Product Change Notification - SYST-20OUBT552

ERRATA - dsPIC33EPXXGS50X Family Silicon Errata and Data Sheet Clarification

Description of Change: Adds silicon issue 42 (I²C).

dsPIC33EPXXGS50X Family Silicon Errata and Data Sheet Clarification

FIGURE 1: EXAMPLE FOR REDUNDANT OUTPUT MODE

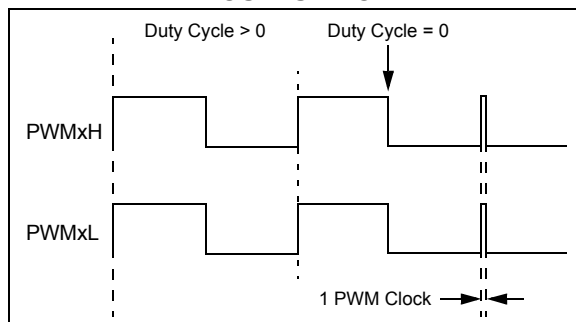
In the Redundant Output mode (IOCONx[11:10] = 0b01) and Push-Pull Output mode (IOCONx[11:10] = 0b10), with the Immediate Update Enable bit disabled (PWMCONx[0] = 0), when the Duty Cycle register is updated from a non-zero value to zero, a glitch pulse of a width equal to one PWM clock will appear at the next PWM period boundary, as shown in Figure 1 (for the Redundant Output mode). The Duty Cycle register refers to the PDCx register if PWMCONx[8] = 0 or the MDC register if PWMCONx[8] = 1.

If the application requires a zero duty cycle output, there are two possible work around methods:

1. Use the PWM override feature to override the PWM output to a low state instead of writing to the Duty Cycle register. In order to switch back to a non-zero duty cycle output, turn off the PWM override. The override-on and override-off events must be timed close to the PWM period boundary if the IOCONx register has been configured with IOCONx[0] = 0 (i.e., output overrides through the OVDDAT[1:0] bits occur on the next CPU clock boundary).
2. Enable the Immediate Update Enable bit (PWMCONx[0] = 1) while configuring the PWMx module (i.e., before enabling the PWMx module, PTCON[15] = 1). With the Immediate Update enabled, writes to the Duty Cycle register can have an immediate effect on the PWM output. Therefore, the duty cycle write operations must be timed close to the PWM period boundary in order to avoid distortions in the PWM output.

FIGURE 2:

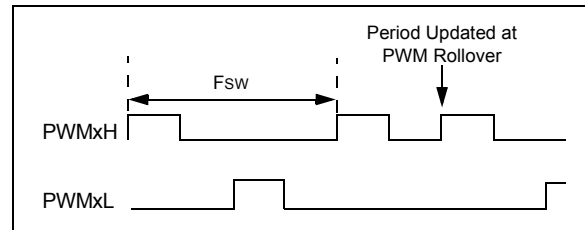
When the PWM module is configured for Push-Pull mode (IOCONx[11:10] = 0b10) with the Enable Immediate Period Update bit enabled (PTCON[10] = 1), a write to the Period register that coincides with the period rollover event may cause the push-pull output logic to produce back-to-back pulses on the PWMx pins (Figure 2).

Ensure that the update to the PWM Period register occurs away from the PWM rollover event by setting the EIPU bit (PTCON[10] = 1). Use either the PWM Special Event Trigger (SEVTCMP) or the PWM Primary Trigger (TRIGx) to generate a PWM Interrupt Service Routine (ISR) near the start of the PWM cycle. This ISR will ensure that period writes do not occur near the PWM period rollover event.

FIGURE 3: MISMATCH OF WORKING REGISTER SET WHEN NESTING MORE THAN ONE INTERRUPT WITHIN INTERRUPTS THAT USE ALTERNATE WORKING REGISTER SETS

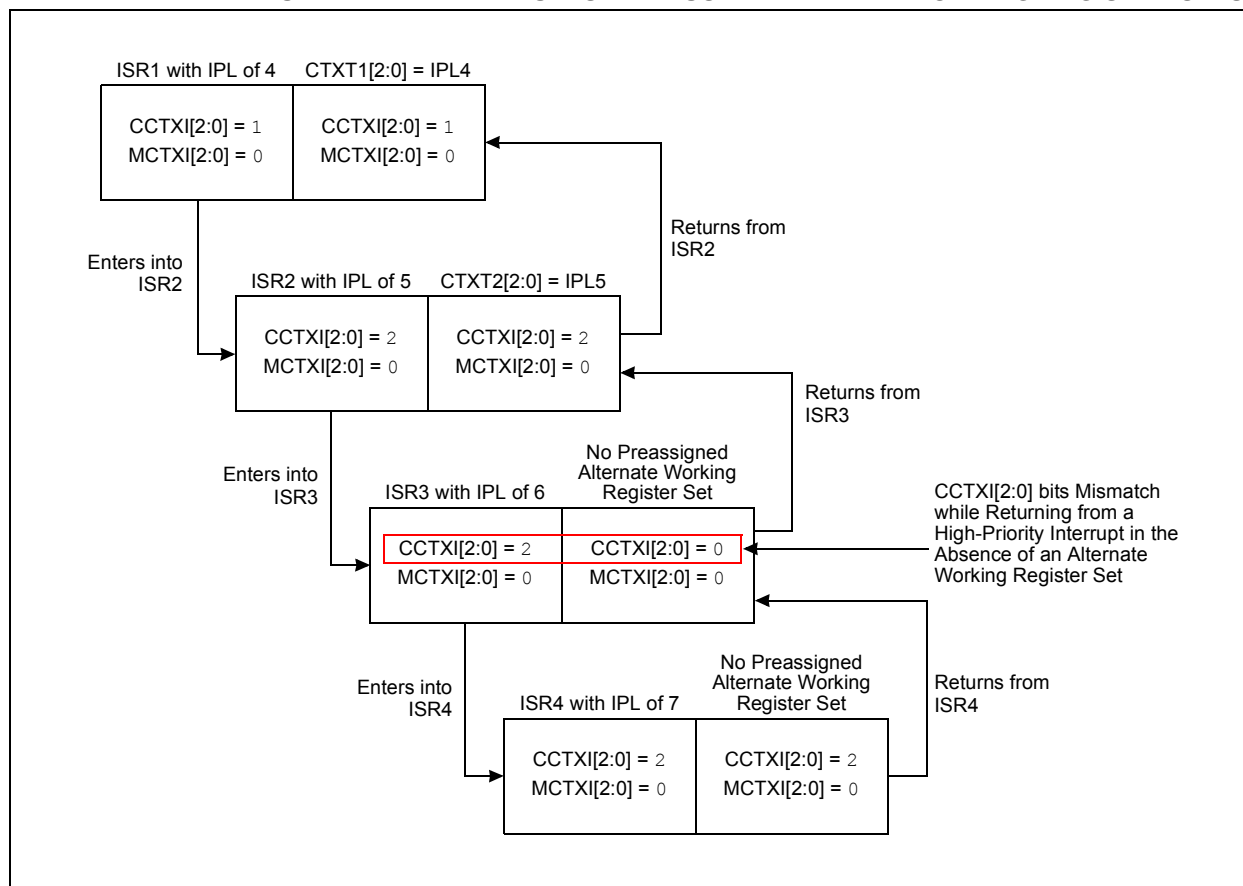
When returning from an Interrupt Service Routine (ISR) by executing the `RETFIE` instruction, in the case of a nested interrupt, the Interrupt Priority Control bits (`IPC[3:0]`) associated with the lower priority interrupt are compared with the `CTXTn` bits field in the `FLTREG` Configuration register:

When using interrupts with the Alternate Working Register Set (automatic context assignment), no more than one ISR without an Alternate Working Register Set must be nested within an ISR with an Alternate Working Register Set.

Issue and work around are illustrated in [Figure 3](#) and [Figure 4](#), respectively. The figures show the status bits, `CCTXI[2:0]` and `MCTXI[2:0]`, after entering into an ISR from a lower priority ISR (left pane), and after returning to the same ISR from a higher priority ISR (right pane).

FIGURE 5: SIMPLIFIED BEHAVIOR

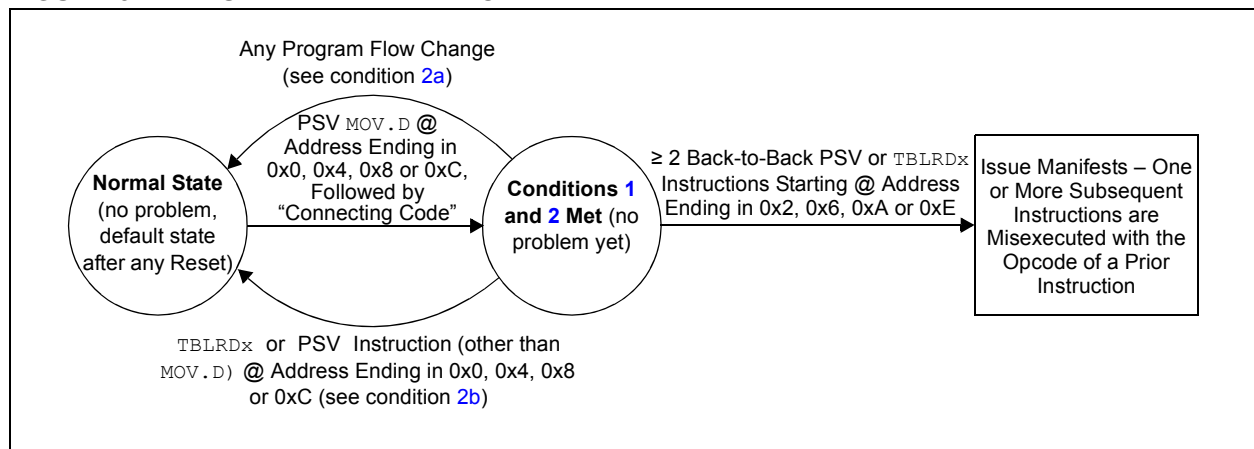
When two or more data Flash read instructions (via Program Space Visibility (PSV) read or table read) are executed back-to-back, one or more subsequent instructions can be misexecuted when all of the conditions in [Table 5](#) occur.

[Figure 5](#) provides an example of the effective behavior.

The issue can be avoided by ensuring any one or more of the requirements are not met. For example:

1. All instances of PSV `MOV.D` can be replaced with two PSV `MOV` instructions instead. Non-PSV `MOV.D` instructions acting on RAM/SFRs do not need to be modified; or
2. If not already present, a program flow change instruction (such as `BRA $+2`) can be inserted above back-to-back data Flash read sequences; or
3. Back-to-back data Flash read instruction sequences can be broken up by inserting a non-Flash read instruction (such as a `NOP`), in between the Flash read instructions; or
4. The alignment of the code can be shifted to avoid the required opcode location addresses.

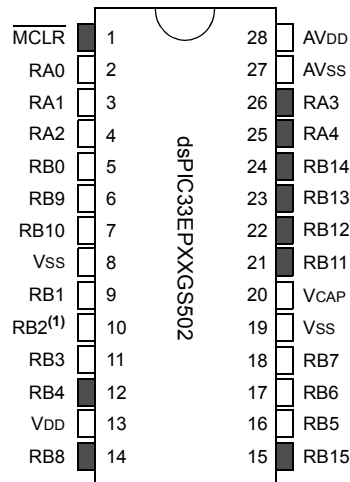
A note has been added to the RB2 port pin, as shown below in **bold**. This note applies to RB2 on all available packages.
